UNITED STATES ARMY
OPERATIONAL EVALUATION GROUP
LIGHT OBSERVATION HELICOPTER,
Fort Rucker, Alabama

6
REPORT OF EVALUATION.

PROJECT NR AVN 2361

1. PURPOSE. To conduct an operational evaluation of Light Observation Helicopter competitive design proposals.

FIG 1 AUTOROTATIONAL CHARACTERISTICS

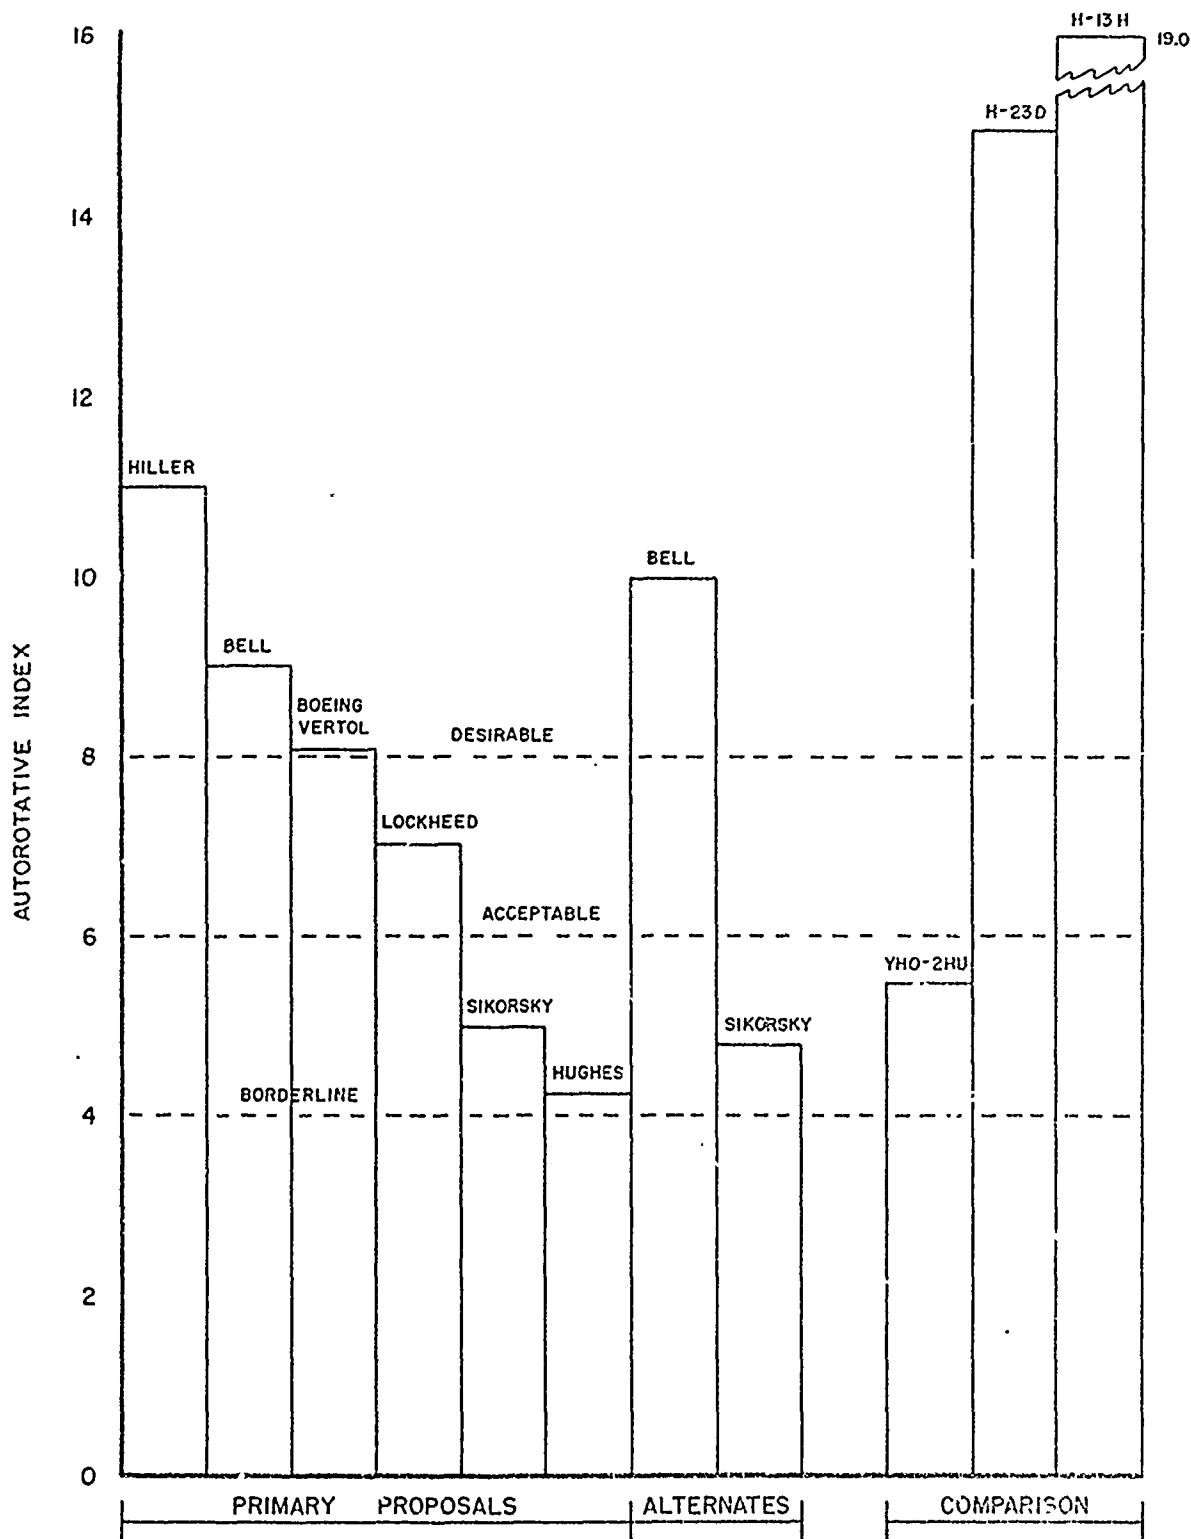
b. This index value of 19.0 can be compared with the index value of 5.5 for the YHO-2HU. Based on these values, it would be expected that the autorotative landing characteristics of the H-13H would be appreciably better than for the YHO-2HU. Flight experience with both aircraft has shown the H-13H has much better autorotative landing characteristics in comparison with the YHO-2HU.

4. The autorotational characteristics, as reflected by the autorotational index (AI), of the top six primary proposals and the top two alternate proposals are shown in Figure 1. As a basis of comparison, the AI of three known helicopters are also shown. Figure 2 is a chart of the factors used and each value. By this method of evaluation and comparison, all proposals are acceptable with the possible exception of Hughes which would be considered a borderline case.

Figure 3

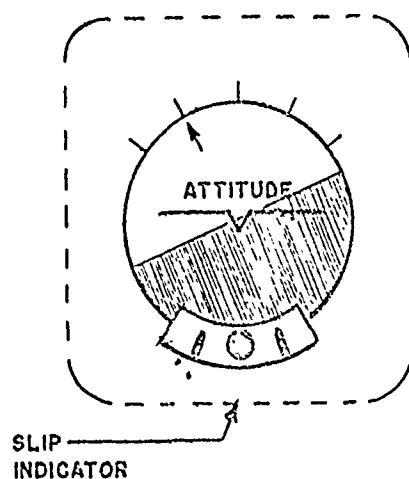
(6) The airspeed, altitude, attitude, and heading indicators shall be mounted in the instrument panel in the approved Army "T" arrangement as illustrated in Figure 3. The altimeter and the attitude, heading, and airspeed indicators shall be of standard three-inch size.

Figure 5

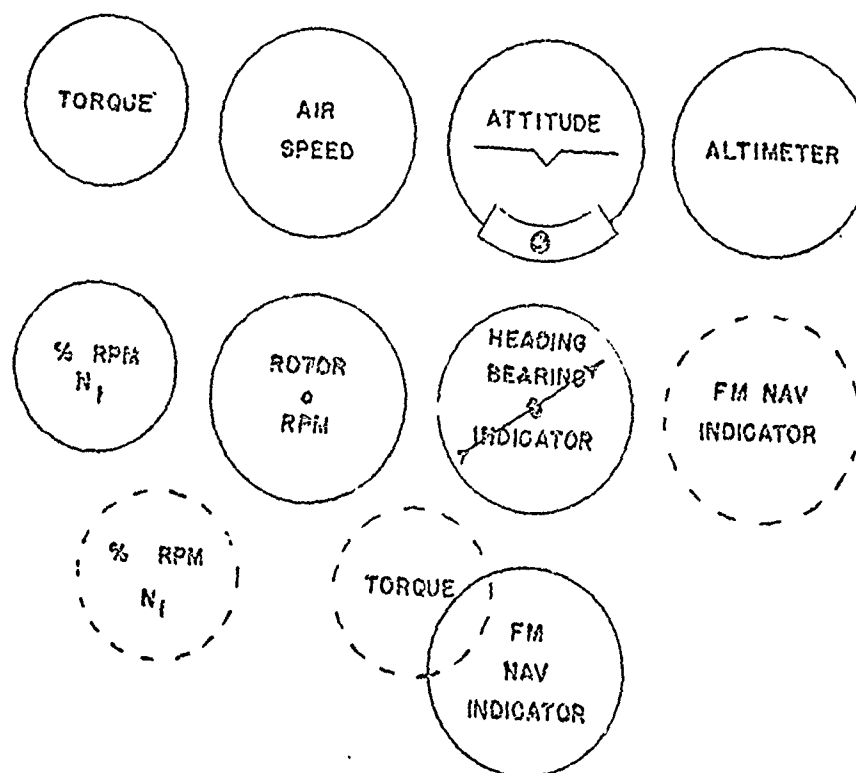
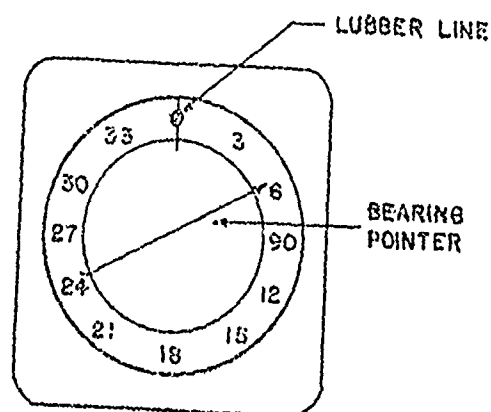
(8) A deviation indicator shall be provided, suitable for display of navigation information from the AN/ARC-54 FM Radio Set Homing System. This instrument shall be located as indicated in Figure 5.

(9) Engine instrument arrangement shall be in general accordance with Figure 5. Locations of engine instruments not shown in Figure 5 shall be subject to approval by the Mock-up Board.

FIG 8 (NO COMPONENTS REMOVED)

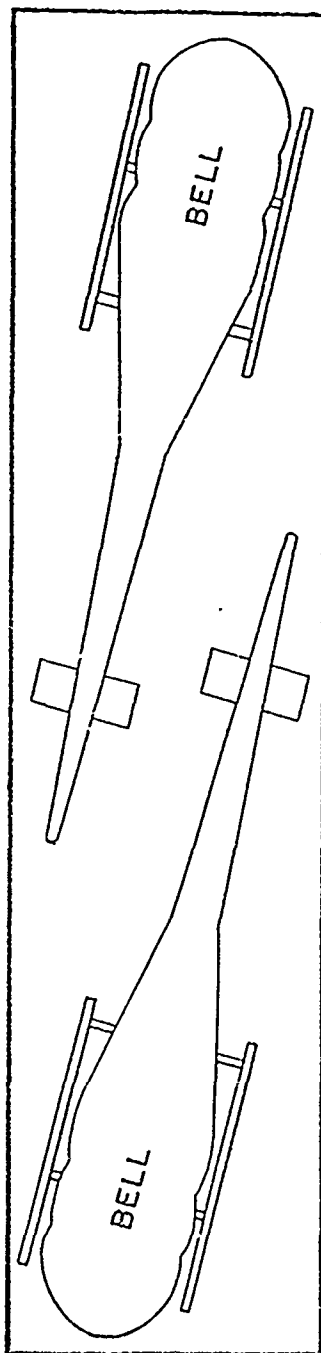
4. <u>Air Transportability</u>					
Nr that can be transported in C-130 without major disassembly (see Figures 7 thru 11)	3 (Note 4)	0 (Note 5)	2	3	5. Must remove main rotor & mast. Does not meet MC. It is questionable that re-assembly can be accomplished in 1 hour for Phase II reqmt. Will meet Phase III reqmt.
